CWF 2016-03

West River CSO Improvement Project

CWF 2016-03 - ADDENDUM No. 7

April 19, 2018

Requested Temporary Storage Area
West River Memorial Park at Route 1

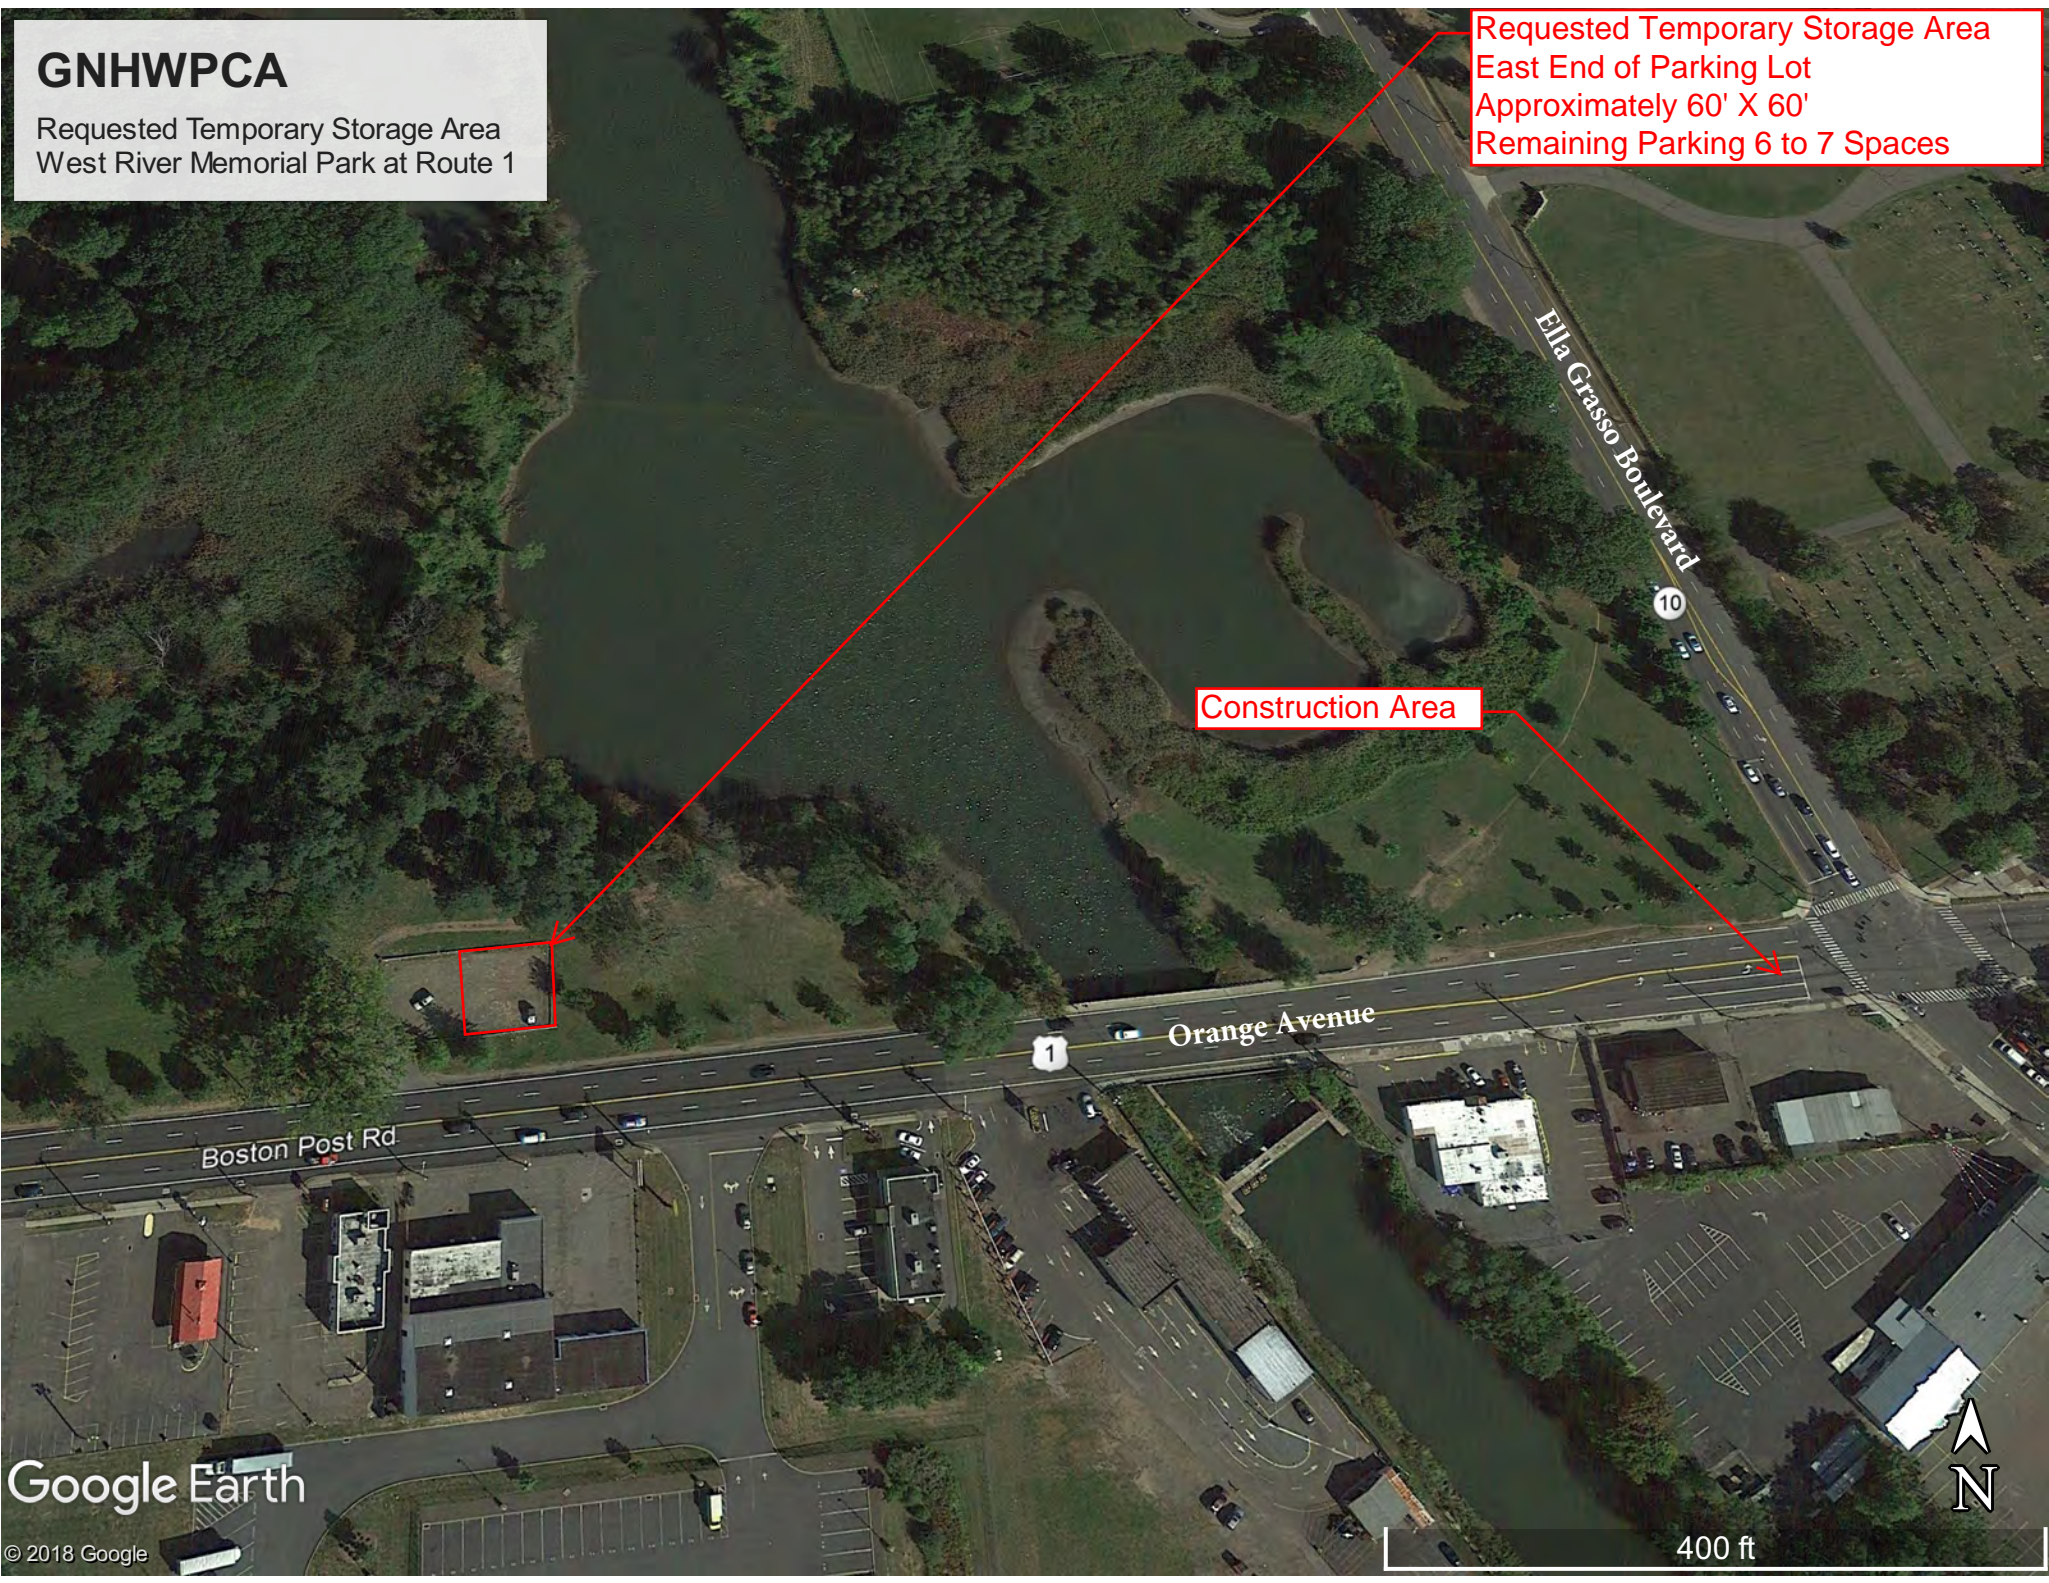
GNHWPCA has obtained permission from the City of New Haven Parks Commission the opportunity to utilize a portion of Parks Land adjacent to Regulator 003 and one adjacent to Regulator 006. These areas are shown schematically on pages 3 and 4 of this Addendum. To utilize these areas, the Contractor must provide the following:

Requested Temporary Storage Area
East End of Parking Lot
Approximately 60' X 60'
Remaining Parking 6 to 7 Spaces

- Restore all areas disturbed by construction activities to original or better condition.
- At Regulator 003 – Parking Lot Area, Re-grade parking area then resurface with an additional 1" thickness of $\frac{3}{4}$ " processed stone.
